## Canopy Retention Analysis

Ladera Vineyards Winery  
Minor Modification P21-00294-MOD and Viewshed P22-00109  
Planning Commission Hearing May 3, 2023

**Re: Ladera Vineyards Minor Modification– Response to Napa County comments on biological resources (File # P21-00294)**

**Figure 1. Land Cover**

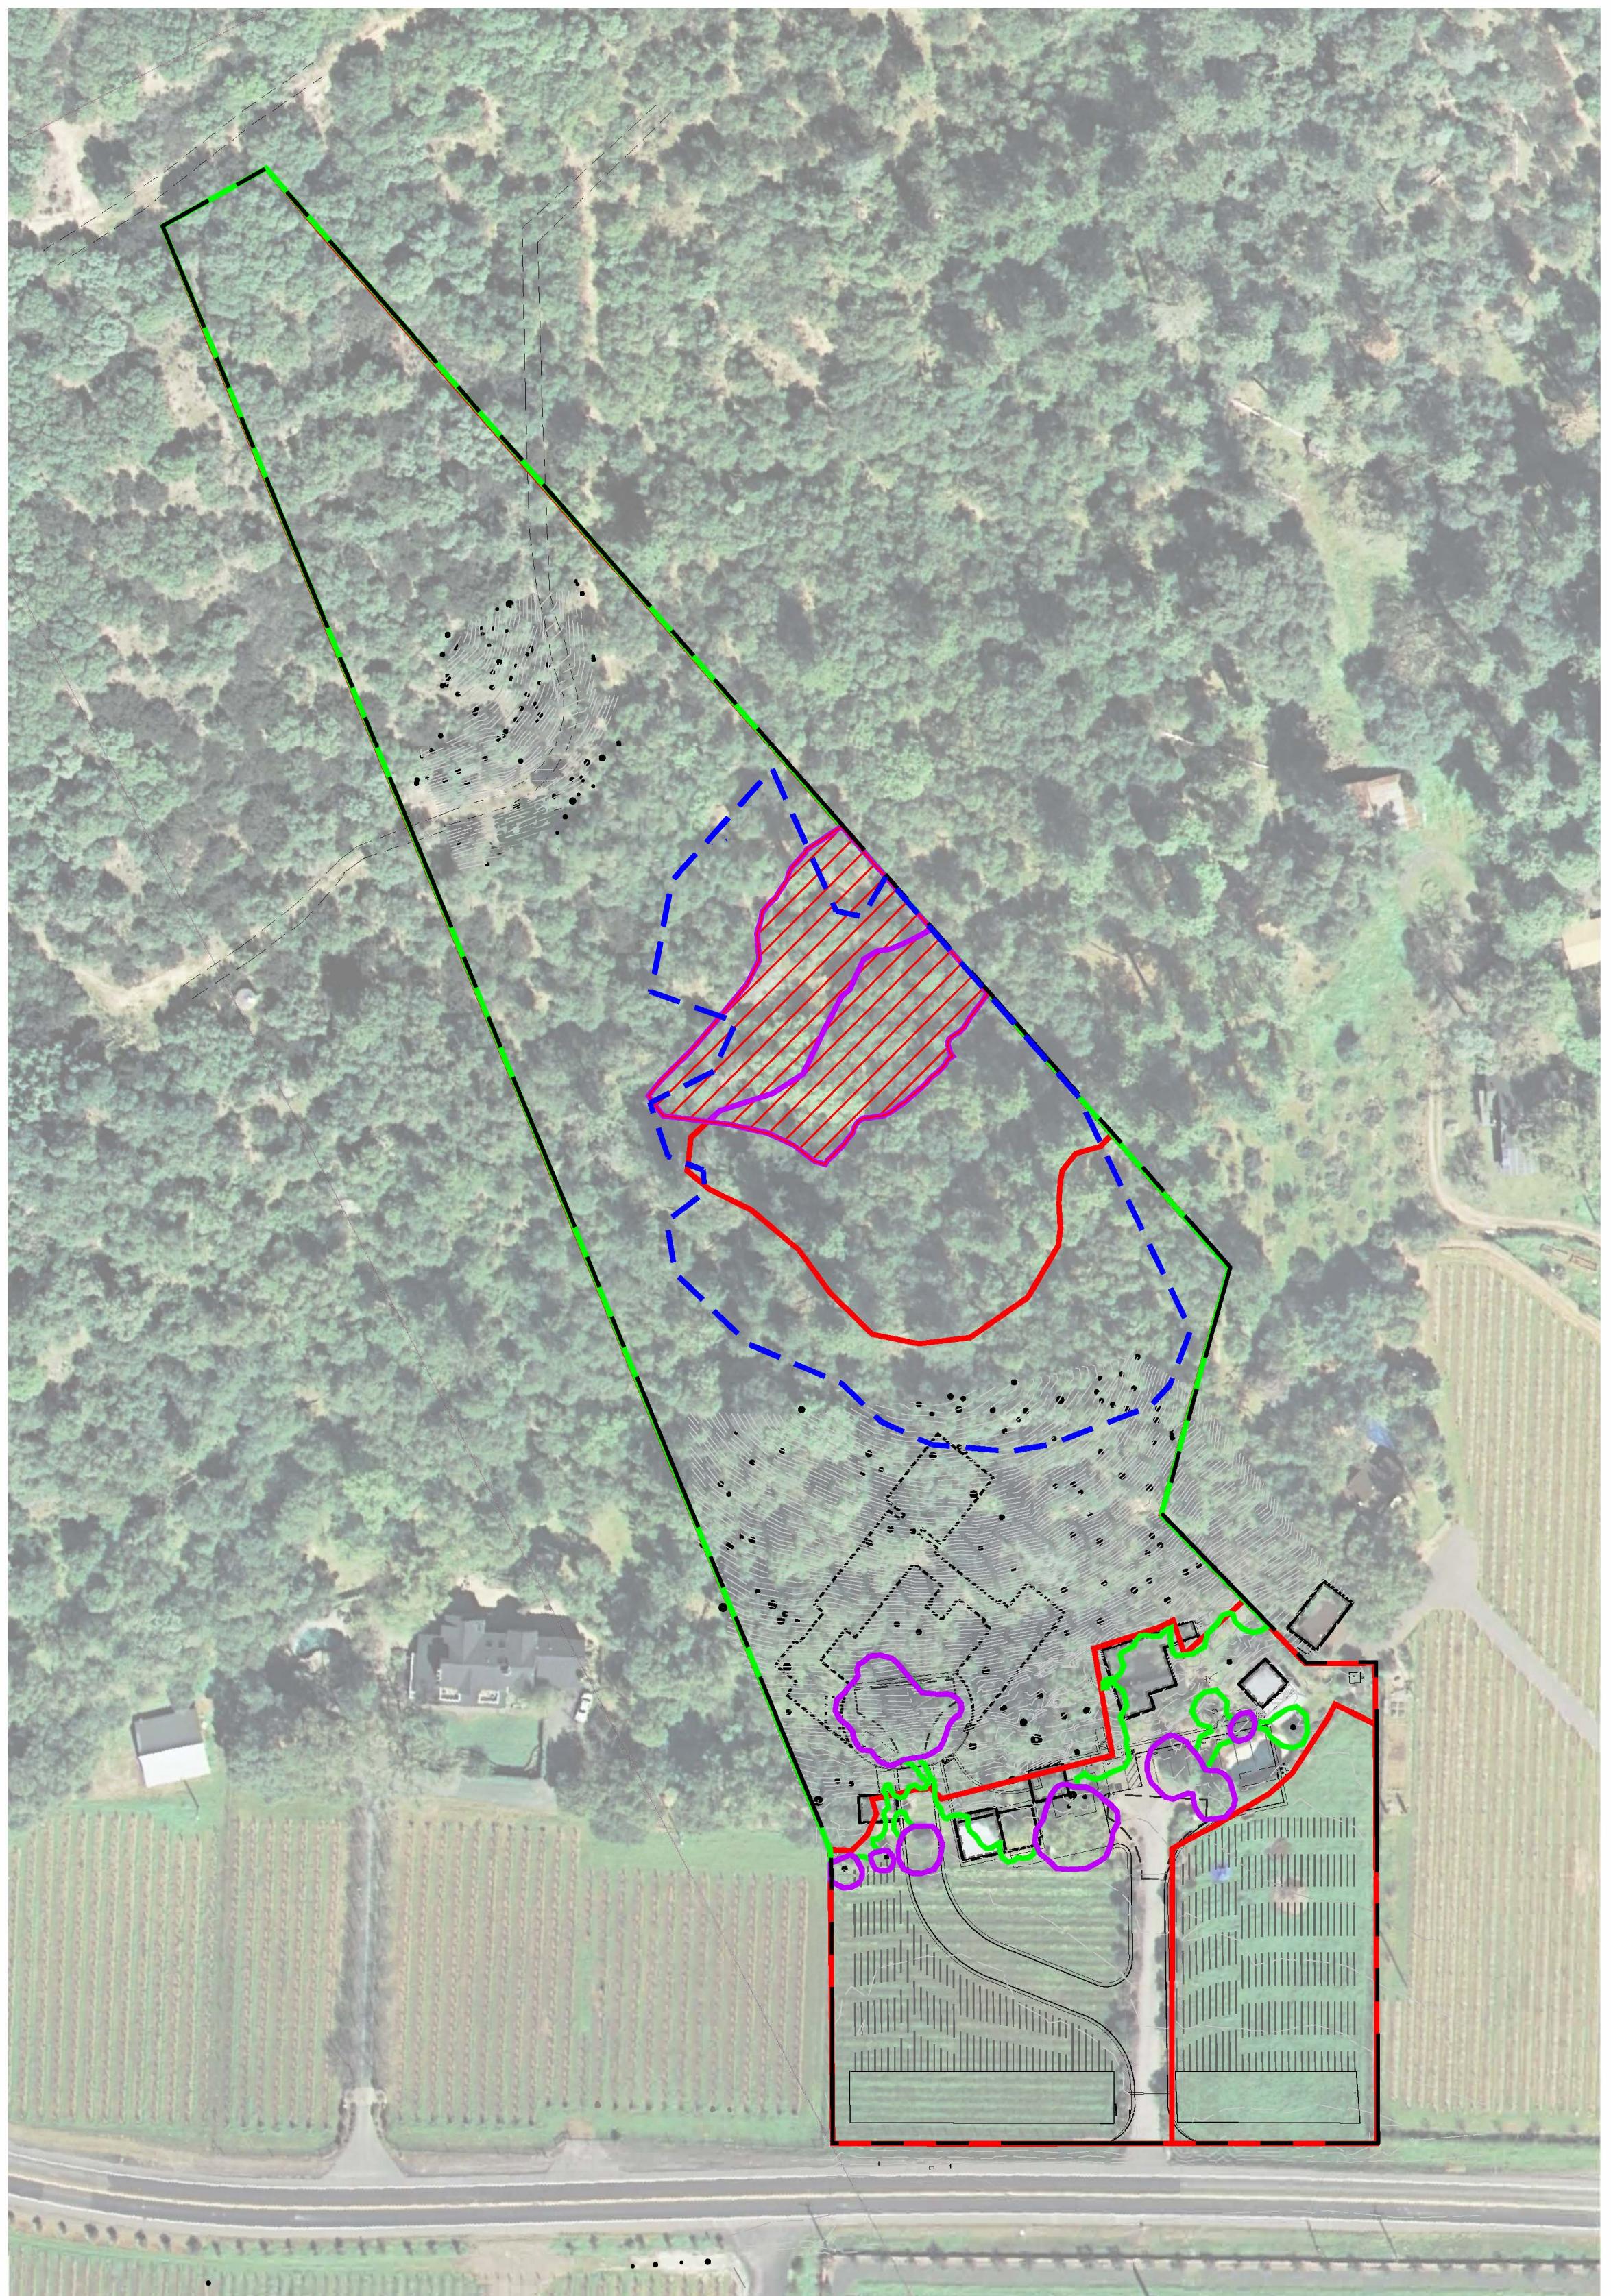
*1. Pursuant to NCC Chapter 8.80.135 (Conservation regulations for fire-damaged properties and fire-damaged vineyards), the vegetation canopy cover analysis occurring on a fire-damaged property in the AW shall be based on the existing vegetation canopy cover as configured on the parcel existing on June 19, 2018. . . . Please revise accordingly. (p. 6)*

For consistency, a revised land cover figure using a 2018 baseline aerial is included in Attachment A. As suggested in the full version of the County's comment, there are no notable differences in the extent of on-site canopy between the two aerials (2016 versus 2018) and thus WRA's mapping is unchanged.

**Figure 2. Canopy Preservation Area**

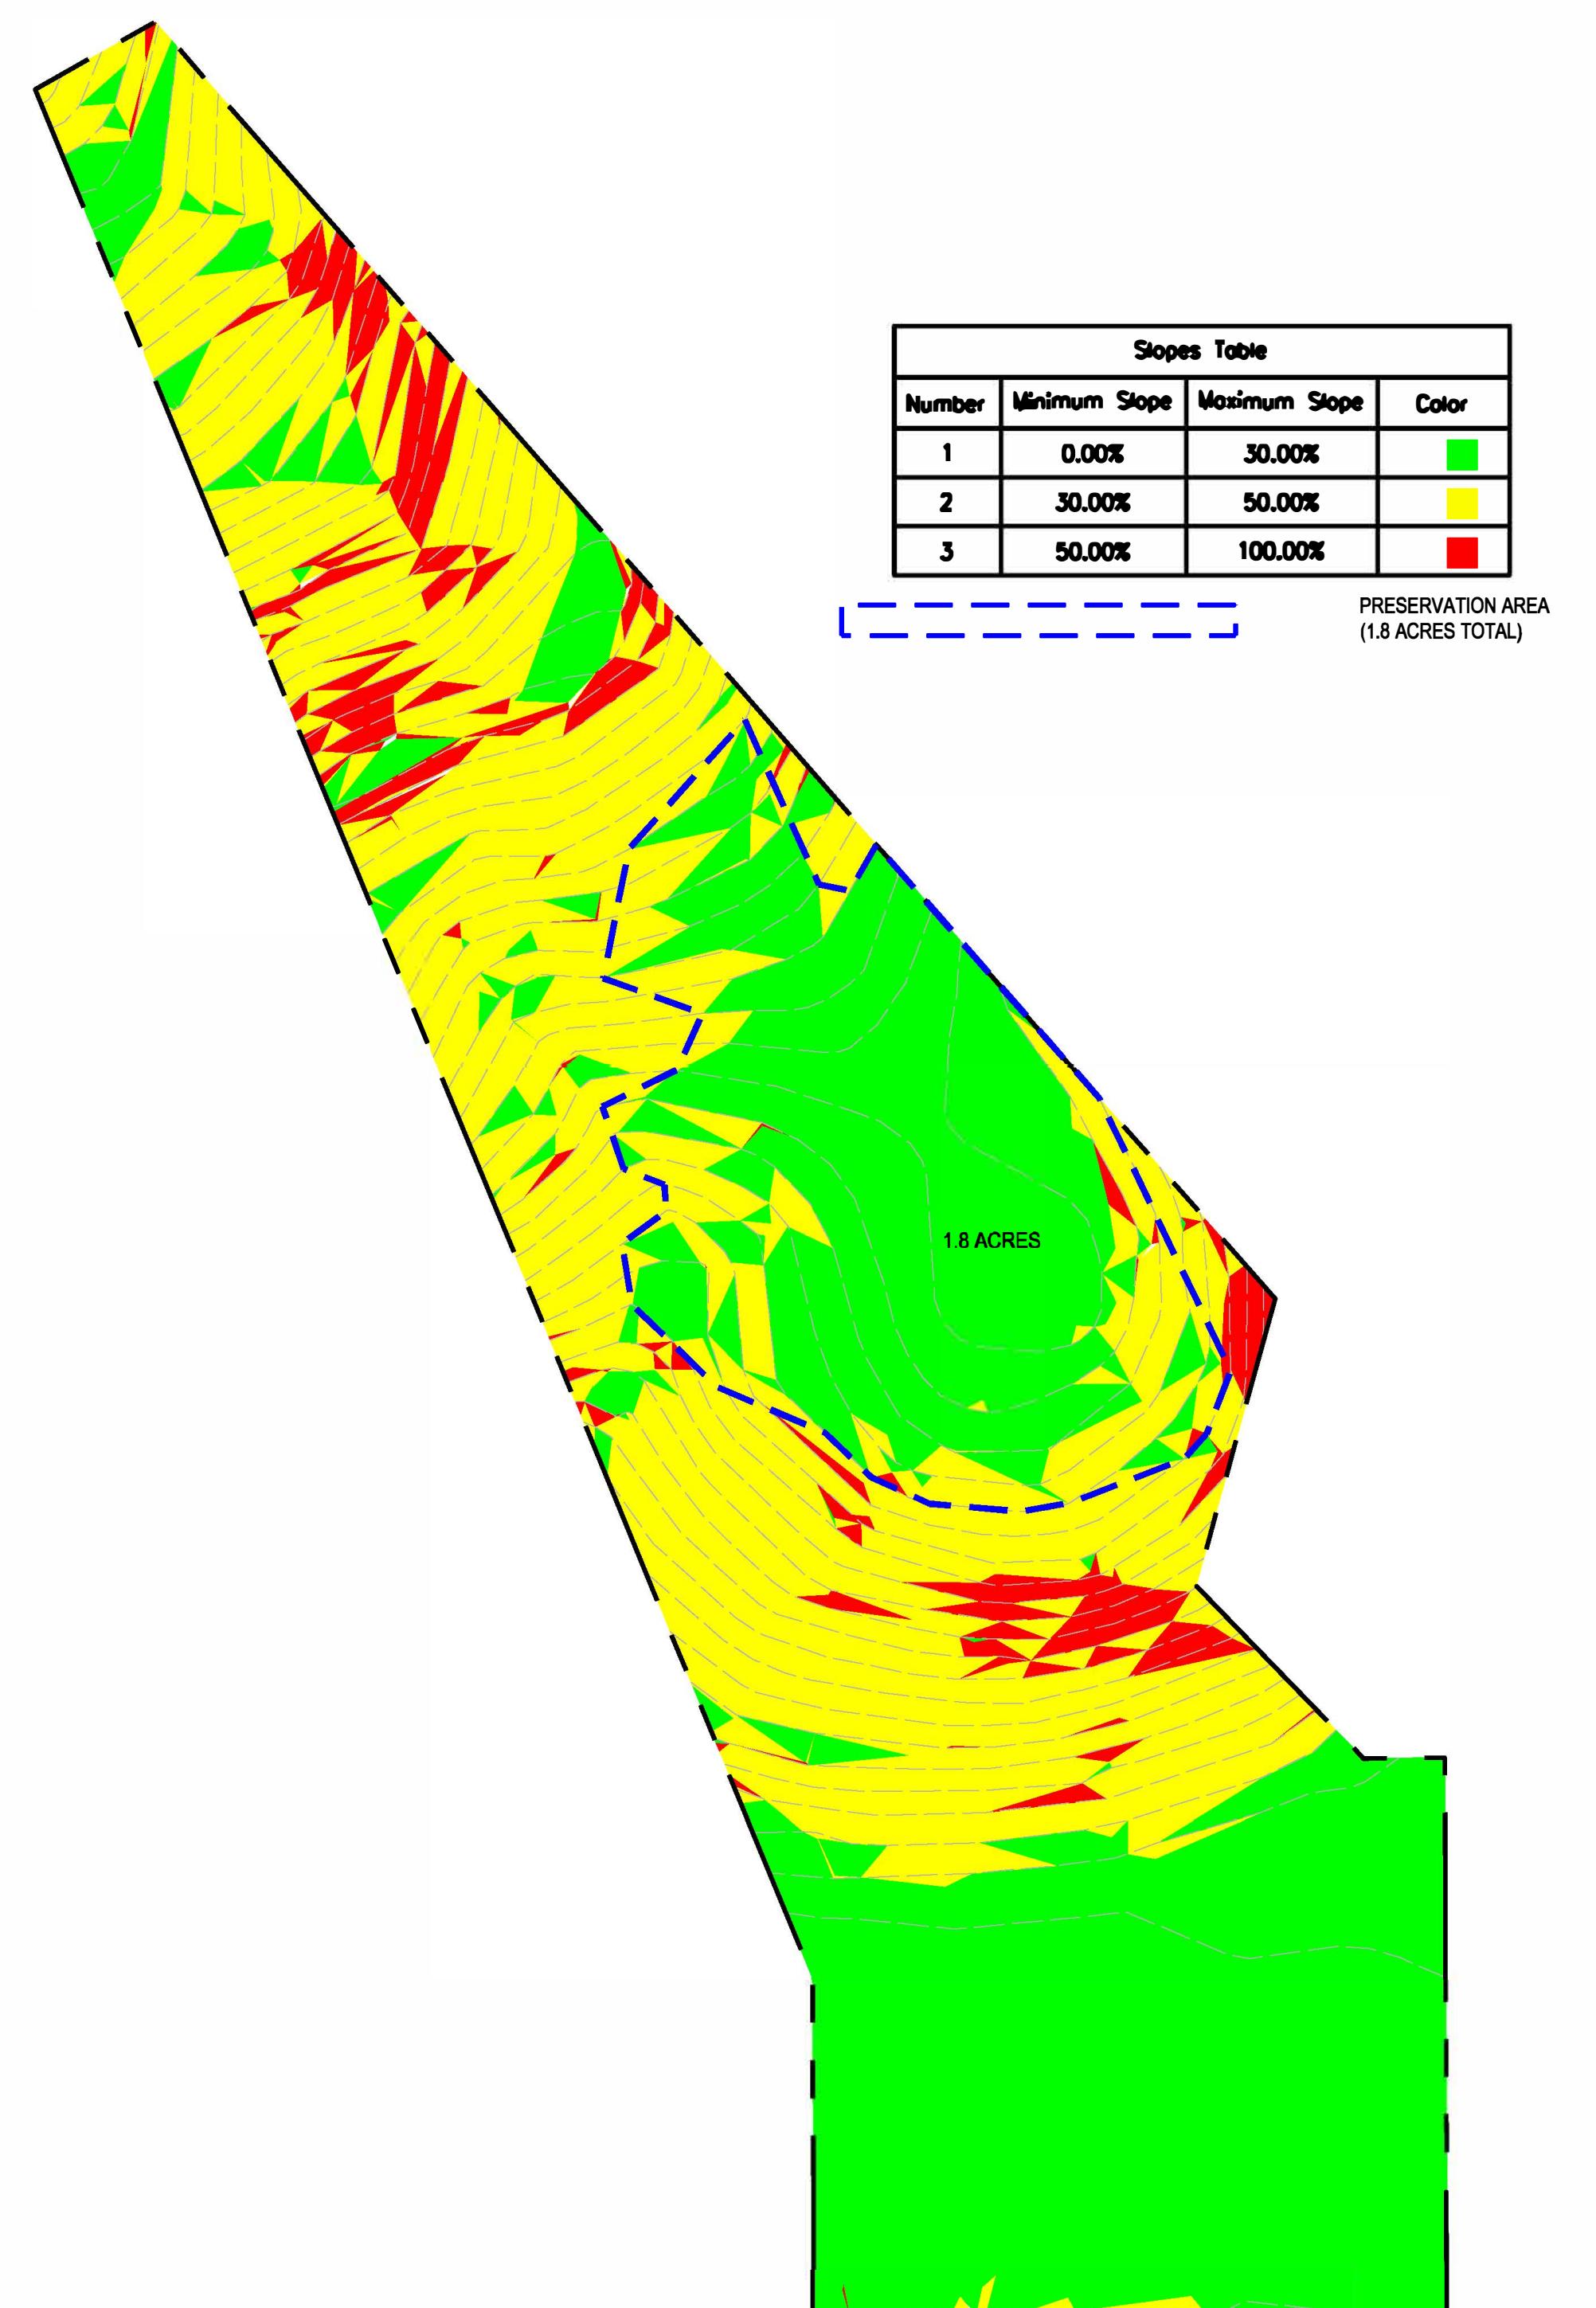
*3. NCC Chapter 18.108.020(D) requires that any vegetation canopy cover removed by the project and/or since baseline be mitigated at a 3:1 ratio by acreage. . . However, the same subsection of the code requires that the location of the permanent replacement or preservation be prioritized as listed, including 1) on-site on lands with slopes of 30% or less and outside of stream and wetland setbacks; and 2) if cannot be reasonably accomplished under (D)(1), on-site preservation may occur on slopes up to 50% that results in the highest biological and water quality protections. Please identify the proposed 3:1 mitigation preservation area per NCC Chapter 18.108.020(D). (pp. 6-7)*

An area of oak woodland and Douglas fir forest proposed for preservation, overlain with both mapped land covers and percent slope on the property, is shown in Figure 2 (Attachment A). This preservation area has been identified in part via feedback from the County and constitutes the required 1.8 acres. The area is sited to specifically include the largest portion of the property where average slope is 30 percent or less and canopy is currently or was recently present. (There are no wetlands or streams within the Study Area, so avoidance of setbacks to such features are not relevant.)

The proposed preservation area includes the bulk of the approximately 0.5-acre cleared area which featured both Douglas fir forest and oak woodland. Although canopy was removed in this area (after 2018), the substrate was not meaningfully altered, and the area remains surrounded by existing forest/woodland. The area currently supports successional shrubbery, and native trees will presumably naturally recolonize the area over time if allowed to do so. The subject preservation area will feature relatively low perimeter-to-area ratio (reducing exposure of the interior to edges), resulting in one block that is directly contiguous with existing canopy on the property to the east.
